LAKE GORDON DAM, (NDS-242), 11

PHASE I INSPECTION REPORT

NATIONAL DAM INSPECTION PROGRAM

Name of Dam: LAKE GORDON DAM
State and State Number: PENNSYLVANIA - 5-1
County: BEDFORD
Stream: EVITTS CREEK, POTOMAC RIVER BASIN
Date of Inspection: APRIL 25, 1978

PLATE X

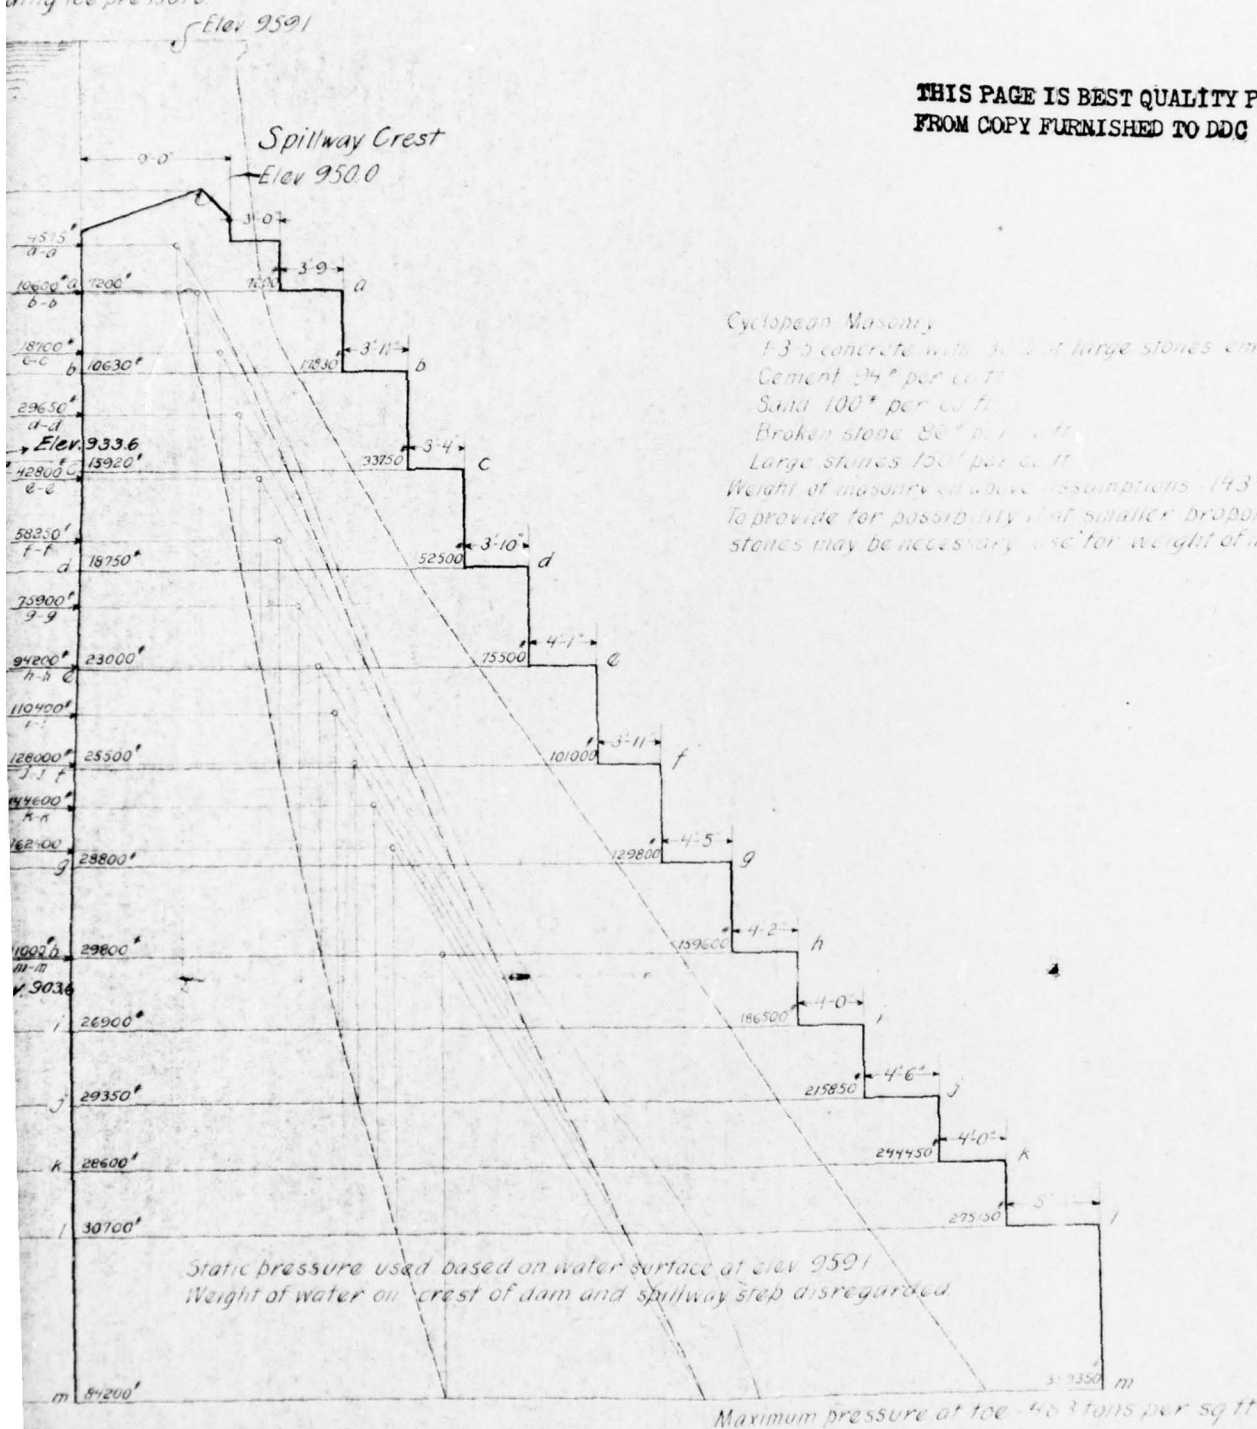
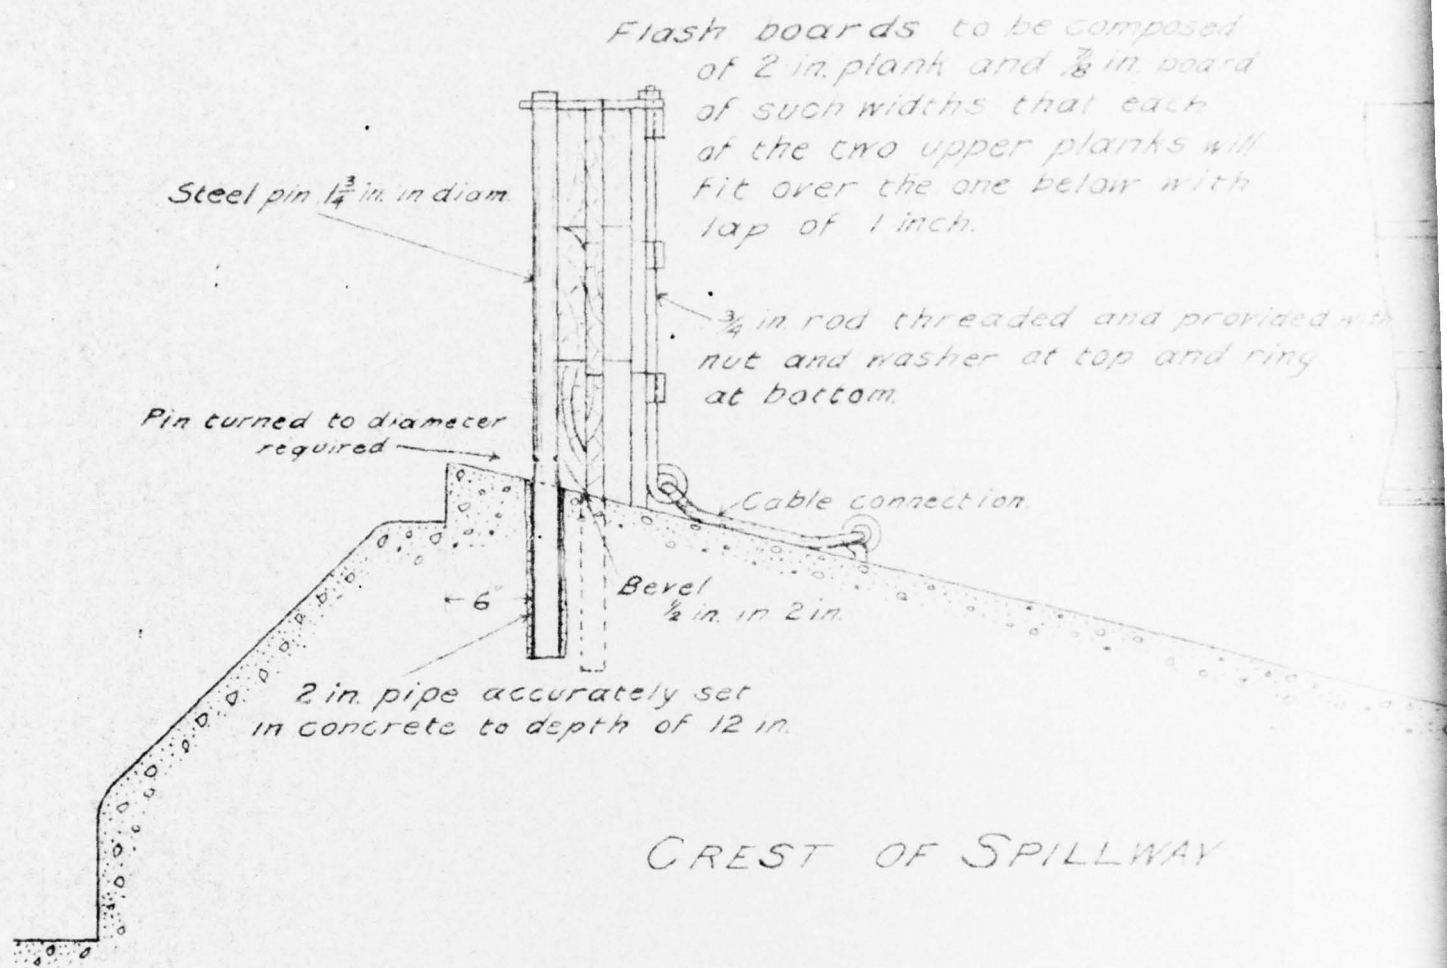
The only available data for review is a drawing indicating the loci of resultant forces for a typical dam section and a typical spillway section (Appendix D, Plate X). The sections were designed for a maximum pool elevation of 959.1 and no uplift under the dam was assumed.

Appendix D, Plate X, indicates the loci for different loading conditions with a maximum pool elevation of 959.0. In Appendix C, approximate calculations have been made for an assumed pool elevation of 963.0 or four feet above the top of the dam. At this elevation, approximately 50 percent of PMF would pass.

The calculations indicate that the resultant force does not fall within the middle third of the foundation. The factor of safety against overturning and sliding seems to be adequate. However, these results are based on no uplift as in the original plans. The actual condition of the foundation and the functioning of the foundation drain is vital information required to evaluate the structural stability of this dam. If uplift would be present, the factor of safety against overturning could be nonexistent.

There is at present not sufficient information available to review all design criteria for this dam under pool levels higher than the design pool level of 959. Additional information is required on the foundation rock strata and the foundation underdrain. The collection of this information and a detailed stability analysis should be a part of further investigation.

EVITTS GREEK WATER COMPANY
 DETAIL OF FLASH BOARDS FOR
 DAM AT LAKE GORDON

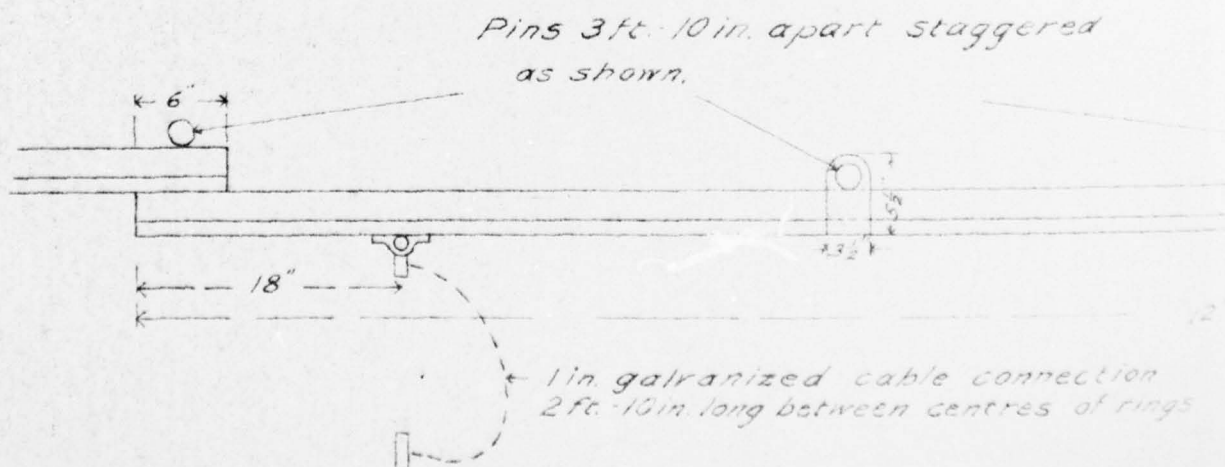
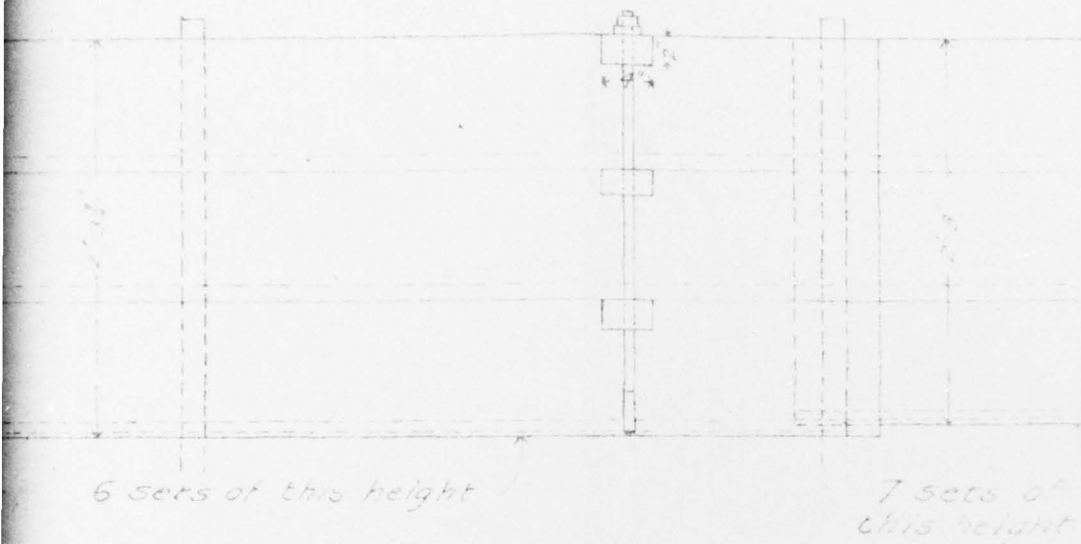
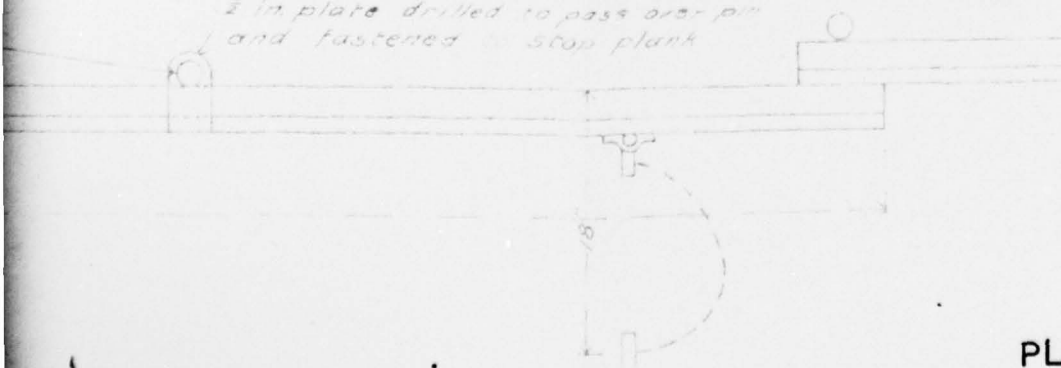
installed flashboards. These remains consist of a continuous strip of 3 inch high x 8 inch wide horizontal planking which is fastened to the crest of the weir with bolts and vertical steel pins on about 6 to 8-foot centers. These exposed pins catch and hold considerable amounts of floating debris.

leakage through the dam. Only the boards were removed and, at the present time, the spillway crest is obstructed by horizontal 3 inch high x 8 inch wide planks which are bolted to the crest by the vertical flashboard pins, which are inserted in holes drilled in the spillway crest, and by miscellaneous drift which catches on the pins. The above items reduce the hydraulic efficiency of the spillway opening and it appears that they should be removed.

1. In order to improve the spillway capacity the owner should immediately remove the obstructions on the spillway crest (pins and 3 inch by 8 inch boards). It should be noted that the spillway will still be seriously inadequate after the crest is restored to its original condition.
2. Studies outlined under Paragraph 7.1.d should be initiated immediately and completed within an acceptable time frame.
